**Development of part of System Six C70 south of
the Maidens. Bunbury endowment land Part of Lot
626, and Parts of Lots 301 - 4**

**City of Bunbury
Homeswest**

**Report and recommendations
of the Environmental Protection Authority**

**Environmental Protection Authority
Perth, Western Australia
Bulletin 789
September 1995**

Figure 4. Proponents' original options (Source: Hart, Simpson and Associates, 1994).

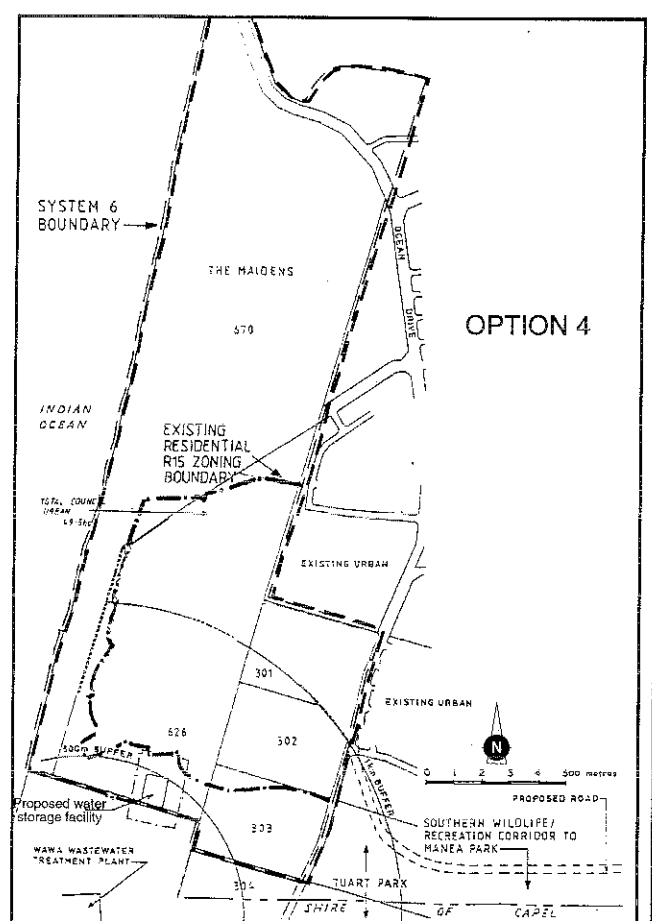
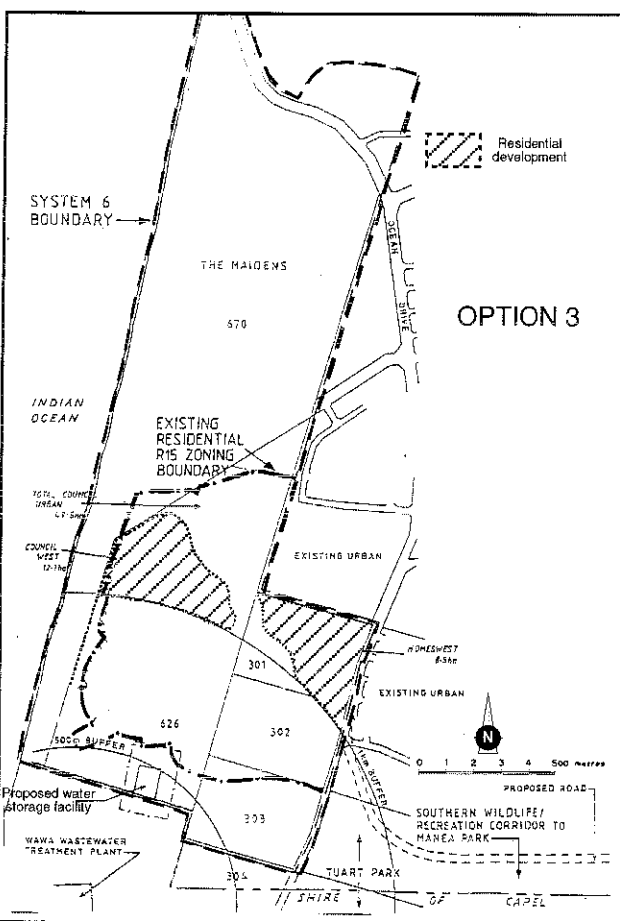
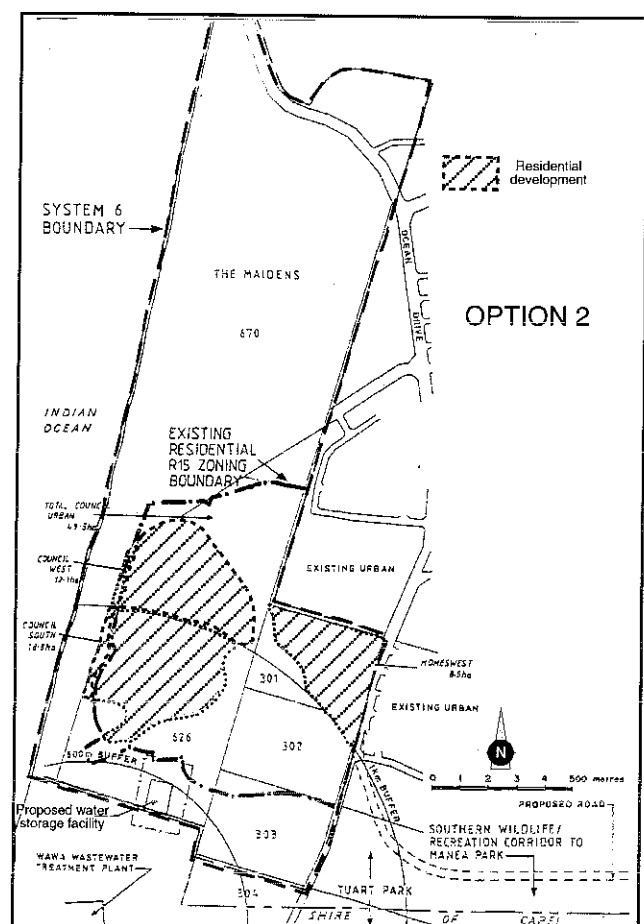
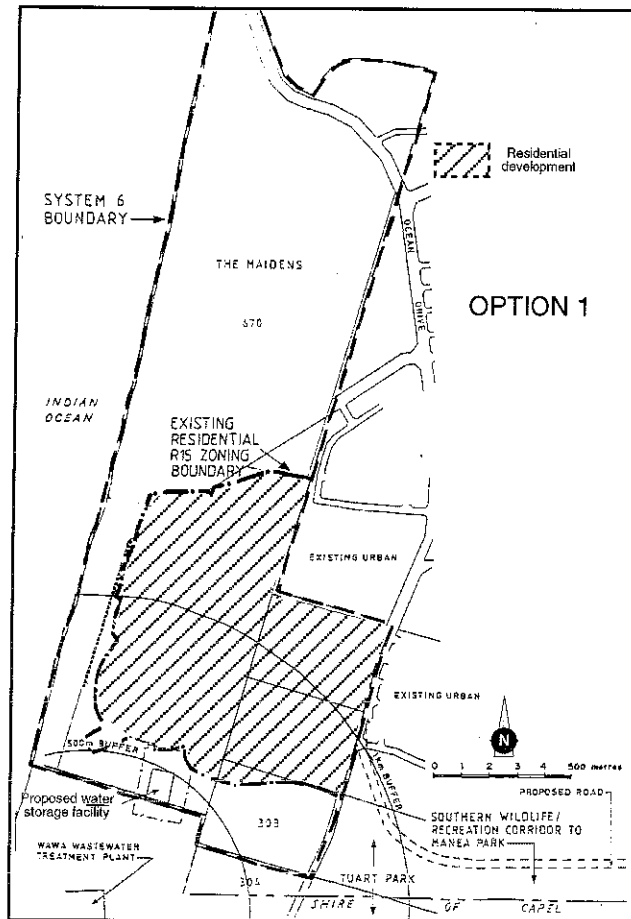
The proposal includes development of a portion of the residential zoned land, retention of some areas for conservation, management of the designated conservation areas and construction of a water supply storage area. For the residential component of the proposal (*i.e.* excluding the water storage facility), the proponents considered 4 alternative development options (see Figure 4):

- Option 1: Develop the majority of the land currently zoned urban (part of Lots 626, 301, 302 and 303) - approximately 70 ha residential, 154 ha conservation.
- Option 2: Develop part of the land outside of a 500 metre buffer to the Waste Water Treatment Plant (part of Lots 626, 301 and 302) - 40 ha residential, 184 ha conservation.
- Option 3: Develop part of the land outside of a 1,000 metre buffer to the Waste Water Treatment Plant (part of Lots 626, 301 and 302) - 21 ha residential, 203 ha conservation.
- Option 4: Conserve the entire C70 area - 224 ha conservation.

The proponents considered that Option 2 was the most appropriate, however, the proponents understood that this Option could not be implemented at this stage because of the Water Authority of Western Australia's requirement for a 1,000 metre buffer around the Waste Water Treatment Plant. Option 3 was the proponents' second choice as it could be implemented immediately without compromising Option 2. Options 2 and 3 are the basis of the proposed development, with Option 2 to proceed only if a reduced buffer around the Waste Water Treatment Plant can be agreed upon (Hart, Simpson and Associates, 1994).

The Bunbury Water Board proposes to build a water supply facility on a high point in the southern area of Lot 626 (see Figure 4). The site is 4.5 hectares with only the central 40 % being cleared of vegetation and the rest remaining as buffer. The outside walls are proposed to

4	The design and location of the proposed water storage facility is environmentally unacceptable and the Water Authority of Western Australia should be consulted regarding appropriate alternatives.
5	Until such time as it can be shown that the buffer area required for the Waste Water Treatment Plant No 2 south of Bunbury can be reduced, the area within 1,000 metres of the inner plant boundary of the Waste Water Treatment Plant should be precluded from consideration for development of sensitive land uses including residential development.

Figure 5. Development scenarios overlain on vegetation of the study area (Source: Hart, Simpson and Associates, 1994).

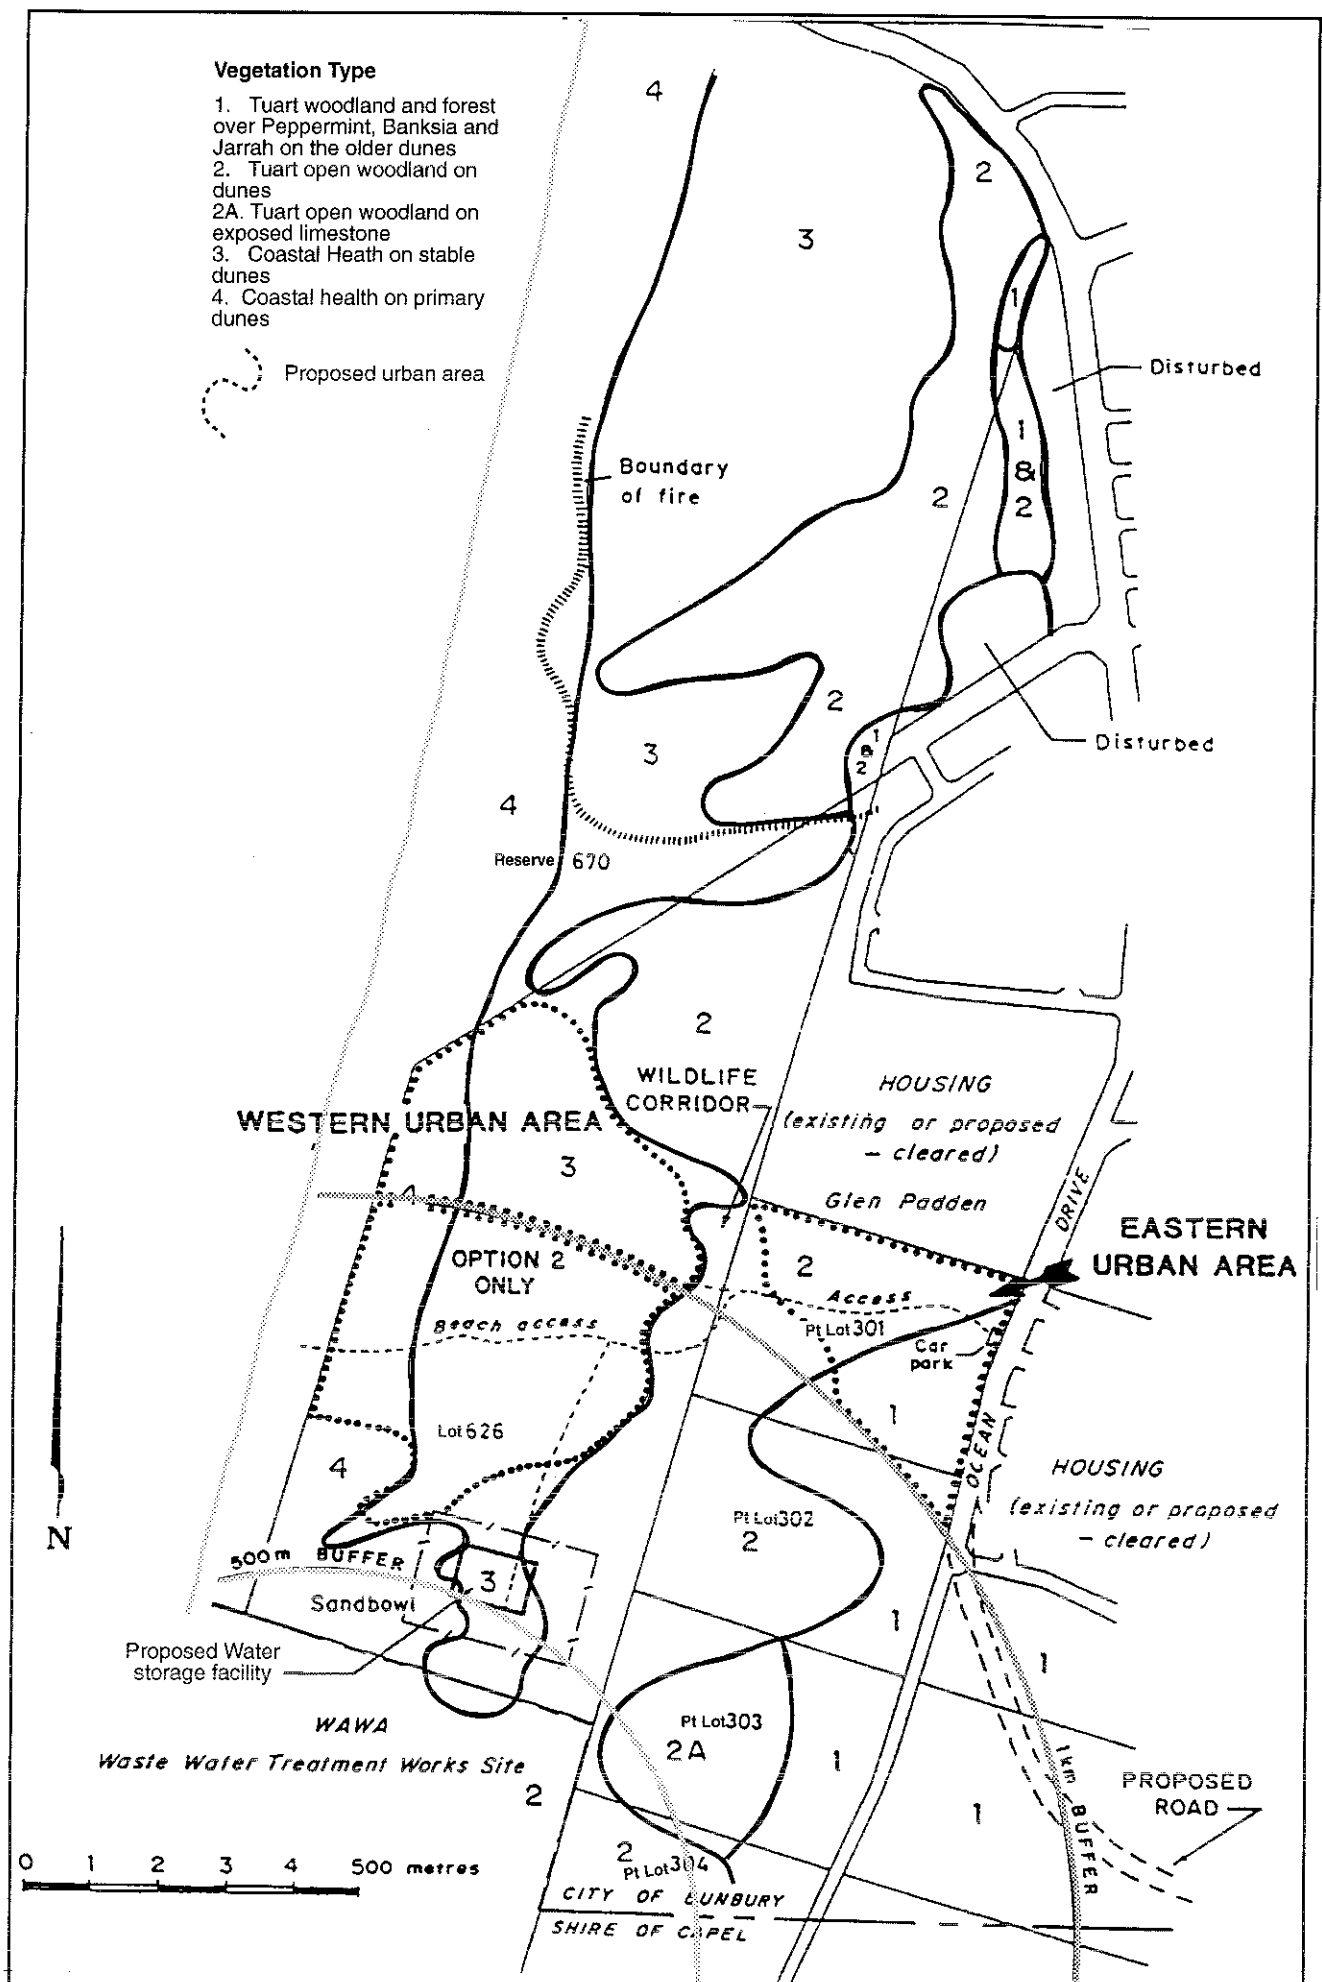
The Sandbowl area (see Figure 5) was seen to provide a further element of recreational use. Submissions commented that this area should be retained as a recreational area for four wheel drive use, provided that clear and distinct roads are outlined to access the area and protect existing vegetation.

In concert with the residential development proposal, the Bunbury Water Board proposes to construct a water storage facility south of the urban zoned land within the System Six C70 recommendation area (see Figure 5). The storage facility would require modification of the landform by levelling the 63 metre high point across a saddle to a nearby peak to the west. Storage would be in a flat pool designed structure which would have its water level at R L 48.5 metres AHD. Approximately 4.5 hectares of land would be enclosed within the facility, 40 % of which would be cleared, though about 5 % around the perimeter would later be rehabilitated as screening. An access track would also be constructed, requiring a further 1.5 hectares of clearing.

According to the Water Authority of Western Australia (1994; submission on Consultative Environmental Review), the buffer lines described in the Consultative Environmental Review (see Figure 5) are drawn from a radius using the middle of the plant as its centre. It is usual that buffers are drawn from the edge of the inner plant boundary fence. This would align the 500 metre buffer with the western projection of the boundary between lots 302 and 303. A similar adjustment is required to the 1 kilometre buffer.

- 3-1 To protect the flora, fauna, conservation and landscape values of the South Bunbury Coastal Land (System Six recommendation C70), the proponent shall not permit residential development in the area described as the 'Eastern Urban Area', Part Lot 301, as indicated in Figure 5 of EPA Bulletin 789 (copy attached).

Figure 7. Indicative 'green belt' around the south of Bunbury (Source: adapted from Department of Planning and Urban Development, 1993).

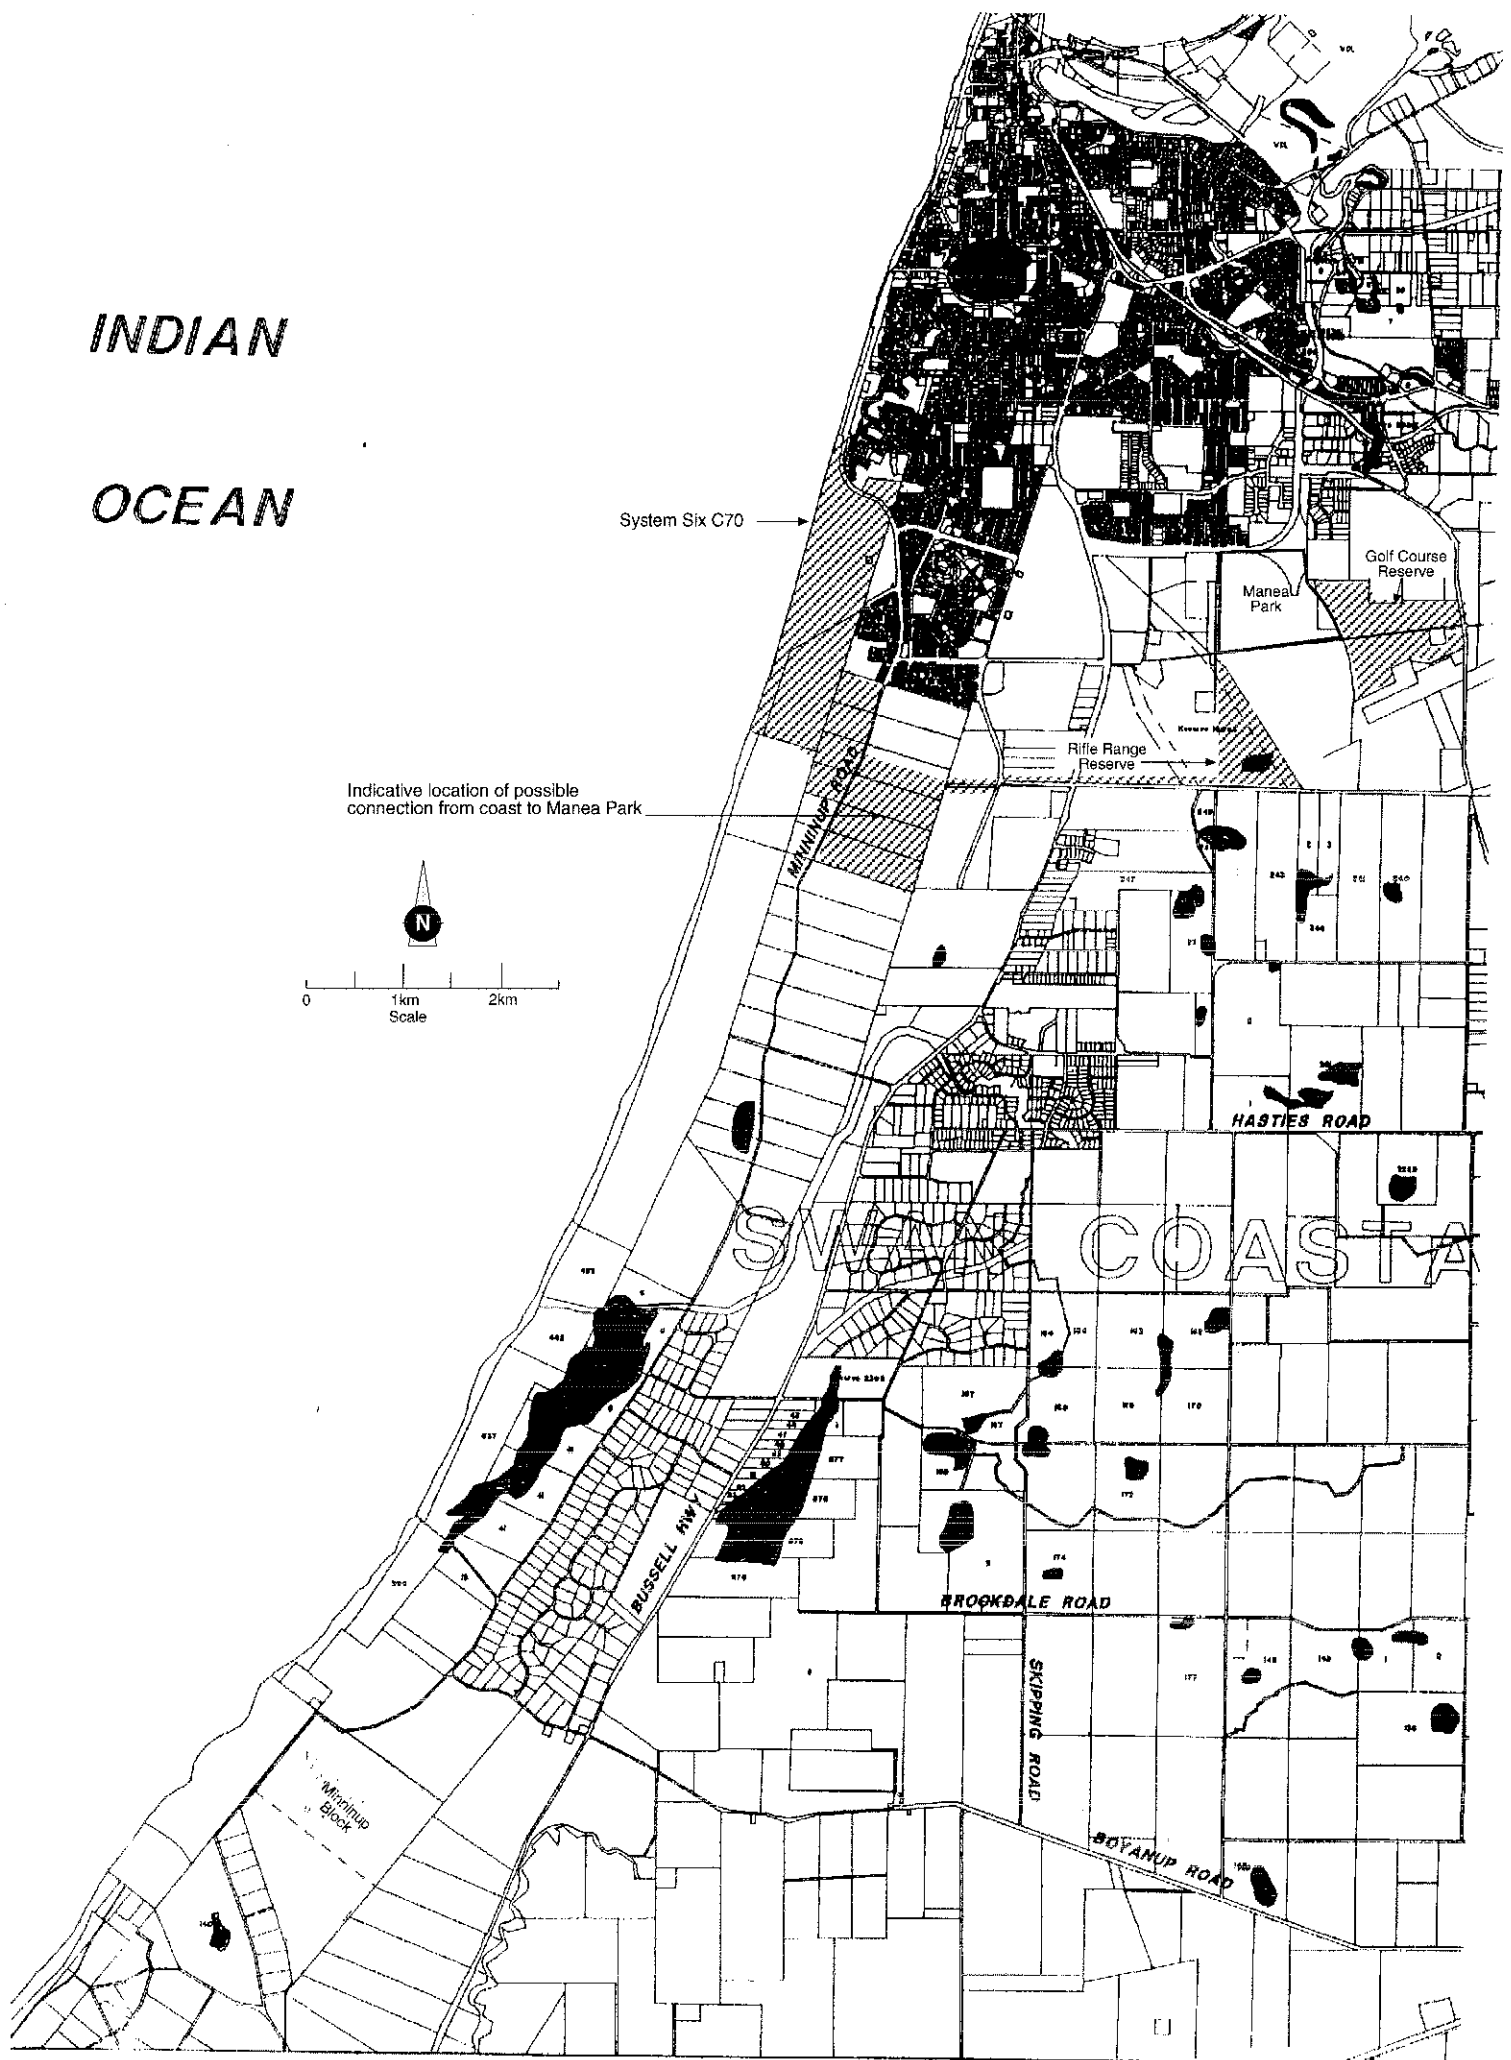
The Department of Conservation and Land Management are very supportive of the corridor connections between 'The Maidens', the Tuart Park and Manea Park proposed in the Bunbury-Wellington Region Plan (see indicative 'green belt' marked on Figure 7). The Department of Conservation and Land Management suggested that appropriate environmental management measures such as limestone pedestrian paths, fencing and signage of the area should precede the sale of residential blocks to ensure that conservation areas are protected prior to people pressures being put upon them if either Option 2 or 3 of the proposal are chosen.

The issue of providing a regional open space connection between the coast and Manea Park (refer Figure 7) is influenced by the decisions made for the study area. As noted above the open space 'green belt' has been endorsed by the Environmental Protection Authority in its comments on the Bunbury-Wellington Region Plan. Retaining the opportunity for the coastal connection would involve the retention of Lot 302 and at least part of Lot 626 as open space. This is discussed further in relation to the availability of alternative sites for residential development.
